**DECISION OF THE HEARINGS OFFICER
ON APPEAL OF ADMINISTRATIVE DECISION**

File No.: 07-180154 LDP (HO 4080041)

Site Address: 6371 SE Yamhill St.

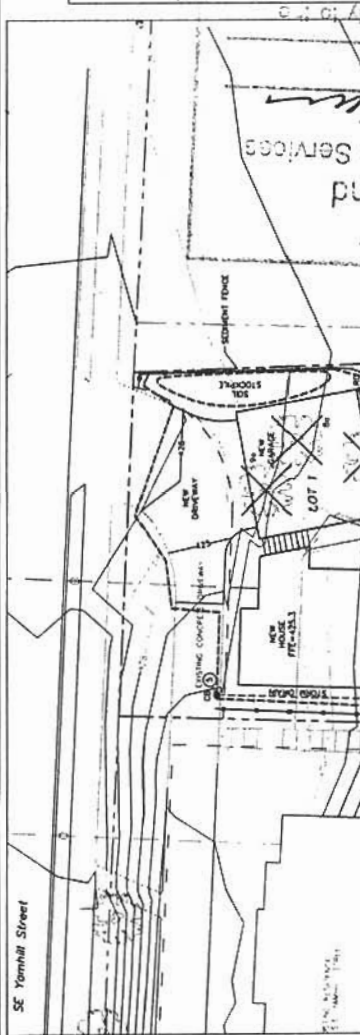
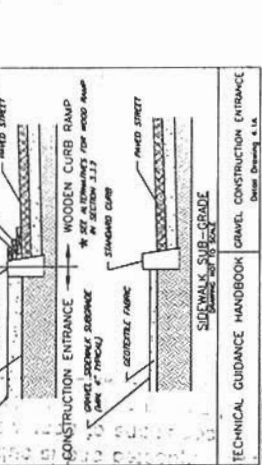
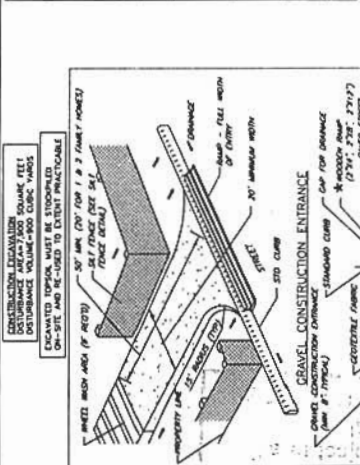
The final tree preservation map in the BDS decision (Exhibit C-5) shows the final arborist markings for tree preservation, but does not match what was drawn on the grading and erosion control plan. It seems that what is on the final grading and erosion control plan takes the minimum preservation from both arborist proposals and merges them as if they are what the arborist has approved. To date, neighbors have not received an updated arborist report explaining how this is sufficient for preserving the trees.

- It reduces the root protection in the north direction where there is proposed grading and a retaining wall for the driveway.
- It proposes a water line installation (Exhibit C-3) through the root protection zone as defined in Exhibit C-5).
- It uses a radial method of fencing instead of the very precise and specific fencing defined by the arborist in Figure 1.

- a. **All trees to be preserved on the site, their species and diameter.** This is a hand written note in the lower left hand corner of the plan.
- b. **The location of water, sewer and other utility easements.** The location of these utilities is shown on this plan, however the easements are not. The easements are shown on Exhibit C-1, the site plan.

- d. **How the requirements of Section 33.248.068 Tree Preservation Requirements are met.** The tree protection detail on this plan noted the details of the construction fencing. Condition of approval D.1 notes that encroachment into the specified root protection zones on the tree preservation plan may only occur under the supervision of a certified arborist.

The Grading and Erosion Control and Tree Preservation Plan (Exhibit C-2) is the tree preservation plan. As noted below, this plan meets the requirements of Section 33.248.065.B.2 (in bold below):

TREE MITIGATION PLAN

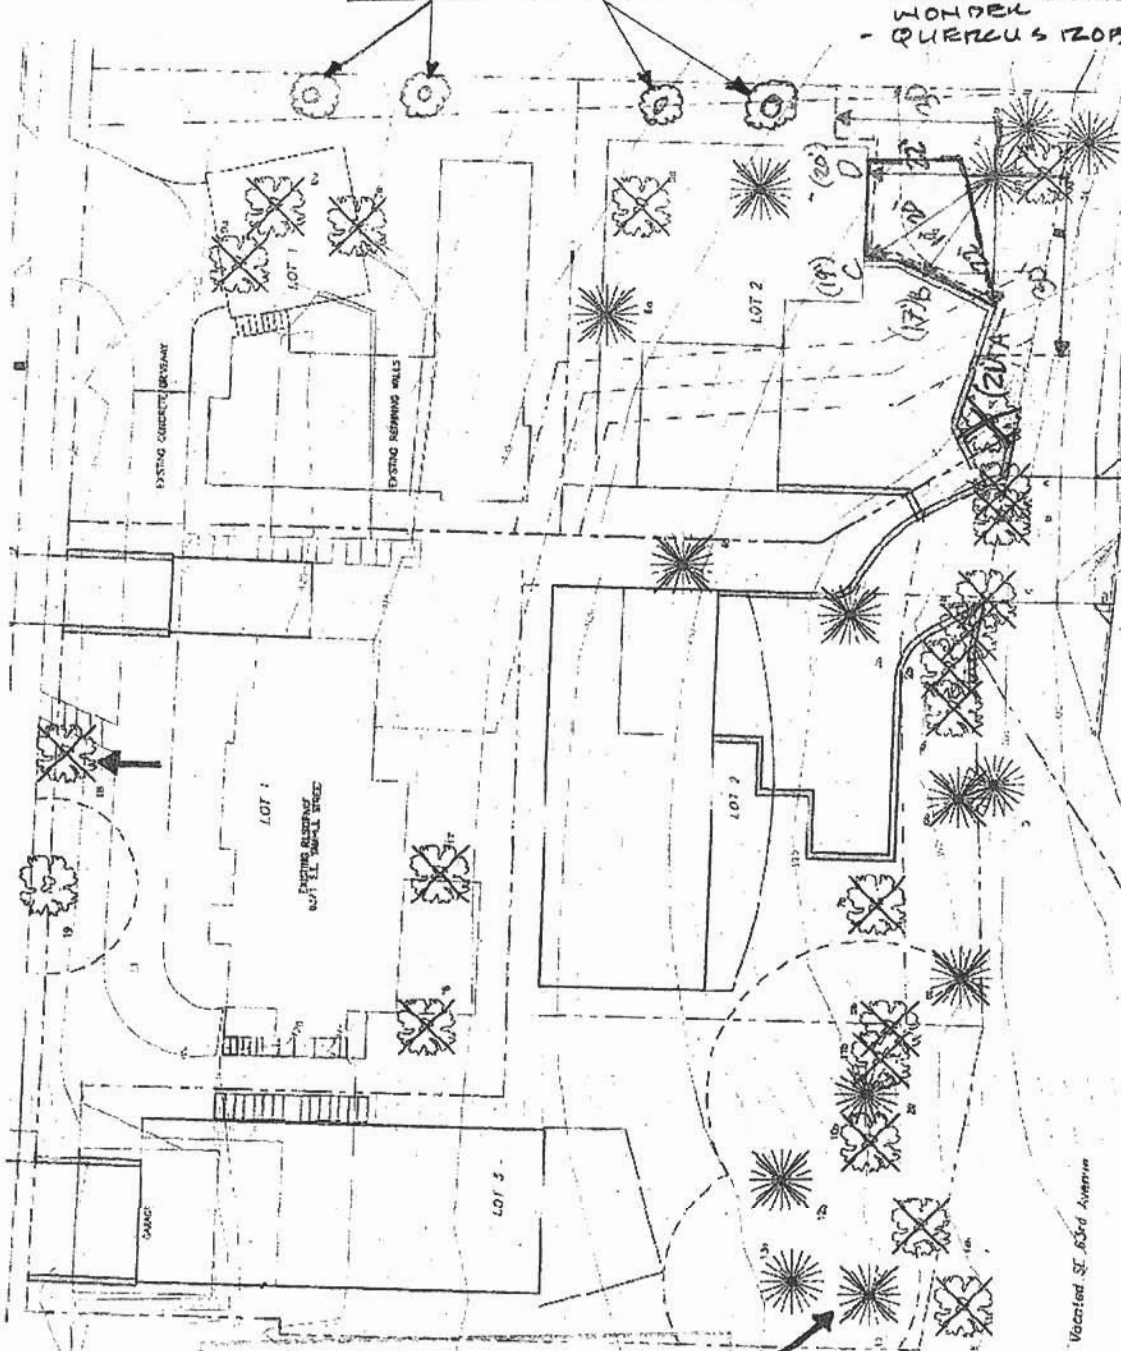
Mr. Shrall stated that according to Section 33.630.200 Tree Preservation Methods, "Trees that will be preserved on individual lots must be permanently preserved through a tree preservation plan, as specified in Section 33.248.065. The mitigation trees should come from the Portland Plant List, defined in Section 33.630.010.

Currently, the proposed land division involves removing two large Douglas fir trees on the site as well as one Douglas fir and one western hemlock on the adjacent site. In total this land division will lose 158 inches of these majestic trees. The arborist proposes using three tree varieties to meet mitigation requirements.

- Malus "Prarifire" is a non-native crabapple tree, not on the Portland Plant List.
- Quercus robur "Fastigiata" is a European oak tree not on the Portland Plant List.
- Cornus "Eddie's White Wonder" is a dogwood tree that is not native, but is similar to the same-genus Cornus Nuttalli, which is native.

None of these trees are on the Portland Plant List. The existing site acts as one of the main gateways to Mt. Tabor Park, and cutting down these trees will forever change the face of that park for the many frequent users. The loss of trees will directly impact the diverse wildlife habitat, it will reduce the value of the homes in the area, and it will increase the heat island effect. Replacing these trees with smaller and lesser variants fails to match the heritage of the Mt. Tabor neighborhood. The neighbors would like to see Douglas fir, Western Hemlock or Western Red Cedar trees planted so that someday the properties should return to their original state and once again reflect the park that binds our neighborhood together.

The tree mitigation plan (Exhibit C.5) denotes the general location of mitigation trees for Parcels 1 and 2. As noted in the hearing, a note has been added to the mitigation plan that the mitigation trees be planted on the subject site and not on Tax Lot 201, which belongs to the property owner to the south. The specific location of the mitigation trees was not identified on the Tree Mitigation Plan. The trees' location should be specified during building permit to ensure that they are placed in an area on the site with a sufficient distance from the house to be built on each lot.

After the administrative decision for this case was rendered, staff determined that the location of the mitigation trees proposed on the mitigation plan were shown on the adjoining site to the south, Tax Lot 201. Upon learning of this, staff made a note in the file indicating that the mitigation trees must be planted on the subject site and not on Tax Lot 201. This is shown on Exhibit C-5, the tree mitigation plan. The location of the mitigation trees shown on this plan is generalized to indicate that each parcel is required to have two, 2 inch trees chosen from the list of trees on the mitigation plan. The exact placement of these trees should be specified in the context of a site plan that is part of a building permit application.

The requirements of tree mitigation plans per Section 33.630.300 do not refer to Section 33.248.090, Mitigation and Restoration Planting, and therefore do not require mitigation trees to be specifically from the Portland Plant List. The requirements of Section 33.249.090 relate to plantings intended to mitigate for the loss of natural resource values. City designated natural resources per Chapter 33.910 are natural resource and functional values protected by environmental zones. The subject property does not have an environmental overlay zone. Therefore, the required mitigation trees on the mitigation plan are not required to be from the Portland Plant List.

2. Two, 2-inch trees chosen from the varieties proposed by the project arborist shall be planted on Parcels 1 and 2 before final approval of building permits for the primary structure on each parcel and that development on Parcels 1 and 2. The trees to be planted shall be chosen from the following species: Malus 'Prairifire' (a variety of plum), Cornus 'Eddie's White Wonder (a variety of dogwood), and Quercus robur 'Fastigiata' (columnar oak) as shown on Exhibit C-5. The mitigation trees may be used to meet T1 requirements.
